This page lists the know errors on the gm5x5x5 PCBs. There are no known issues with the bulk order run (white pcbs), the following information is valid **only** for the prototype run (green pcbs).

### Prototype Run

#### #1 MIDI IO pins

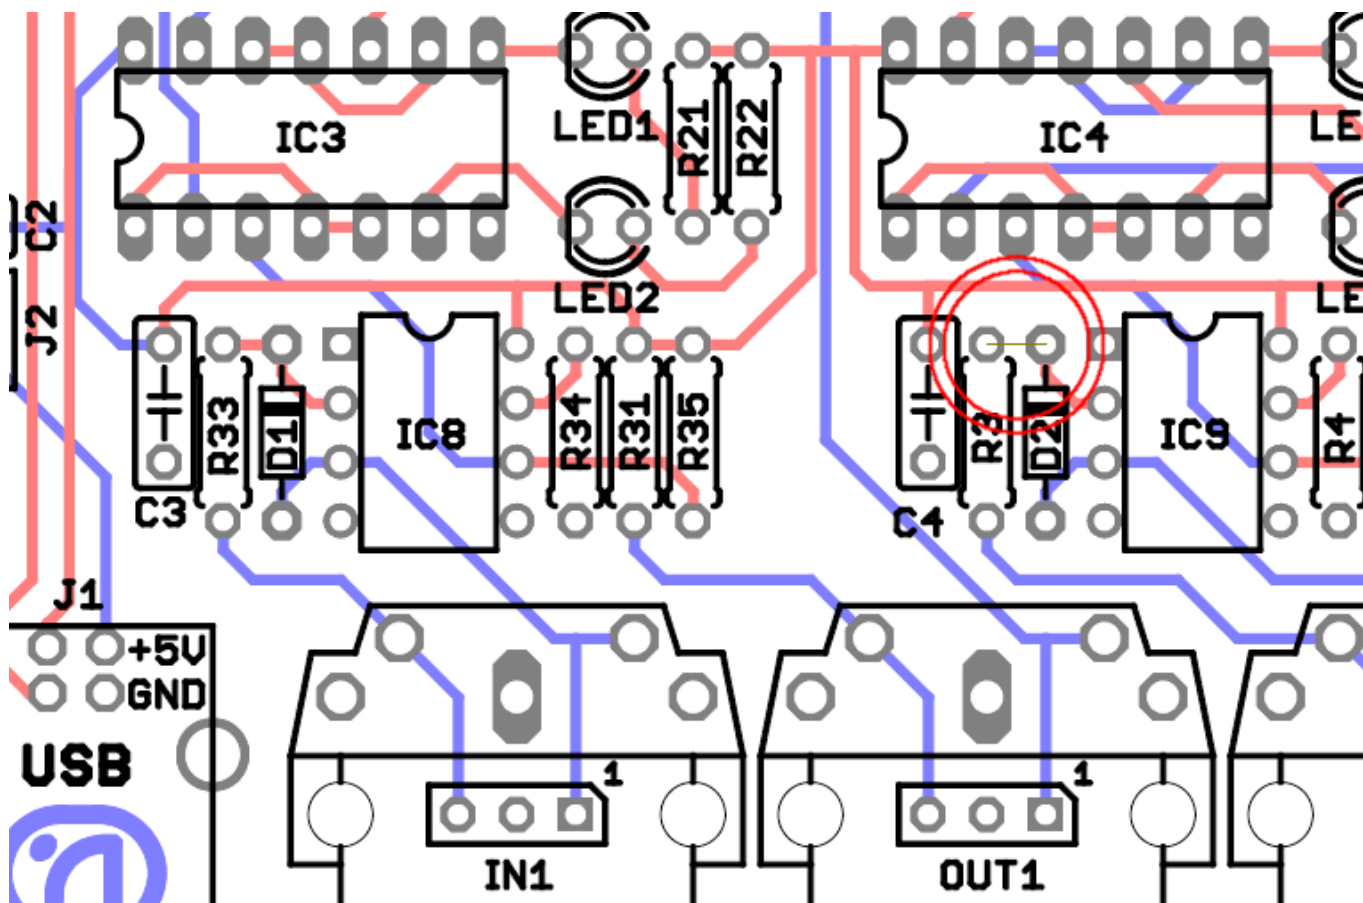
**Problem:** The MIDI IO pins of the midi sockets (Pin 4 + 5) are switched.

**Solution:** Either (1) use the pin-headers if you use sockets that are not mounted on the pcb or (2) break the traces to pins 4 + 5 of the sockets and solder wires to them or (3) solder the midi sockets on the other side of the pcb.
